FRONT SUSPENSION POPPING NOISE WHILE TURNING RIGHT OR LEFT—VEHICLES BUILT BEFORE 4/8/2005

TSB 05-9-11

FORD:
2005 Mustang

Figure 1 - Article 05-9-11

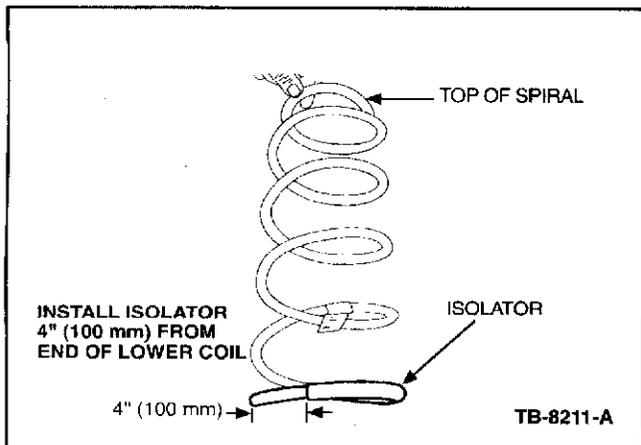
1. Remove the strut and spring assembly. Refer to Workshop Manual Section 204-01.
2. Disassemble the strut and spring assembly.
3. If the springs do not have a rubber isolator on the bottom spring coil, install isolators. Clean off any dirt prior to installing the isolator. The isolator should be installed 4" (100 mm) from the end of the coil (Figure 1).
